Pentium® II Xeon™ Processor Specification Update

Release Date: February 2000

Order Number: 243776-020

The Pentium® II Xeon processor may contain design defects or errors known as errata which may cause the product to deviate from published specifications. Current characterized errata are documented in this Specification Update.

Figure 1. An Example of Microcontroller Driven Thermal Management

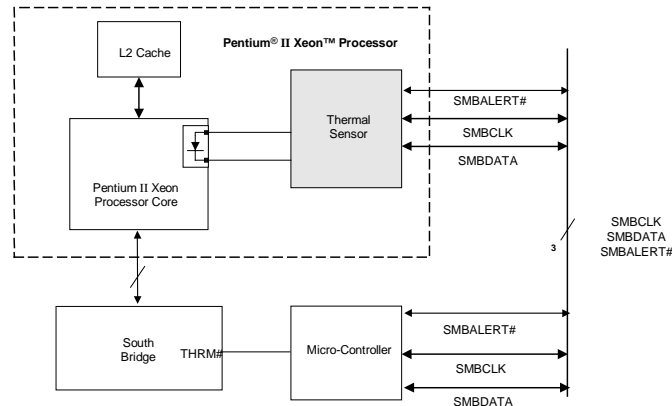
D30. Thermal Sensor May Assert SMBALERT# Incorrectly

Problem: The Pentium II Xeon processor has a thermal sensor that monitors the processor core's temperature. The thermal sensor asserts SMBALERT# if the processor temperature exceeds the temperature limits set in the Alarm Threshold Registers (T_{HIGH} , T_{LOW}). It also sets the corresponding Status Register bits to identify the cause of the interrupt. Figure 1 gives one example of the how the SMBALERT# signal could be used in a system.

Under the conditions described below, the thermal sensor incorrectly generates the SMBALERT# interrupt. All of the following conditions must be met to trigger a false interrupt:

Workaround: Three different (mutually exclusive) workarounds are possible:

1. Before servicing an interrupt from the thermal sensor, read and compare the processor thermal reading with the threshold limits (T_{HIGH} or T_{LOW}). Figures 2 and 3 provide basic flowcharts for the implementation of this workaround in an interrupt driven system.
2. If the firmware implemented polls the Status Register only, then before taking any action, re-read the temperature register and do a comparison with the alarm threshold limits (T_{HIGH} or T_{LOW}) to determine if the value is actually still within the temperature window.
3. Use a temperature polling scheme to monitor the processor temperature
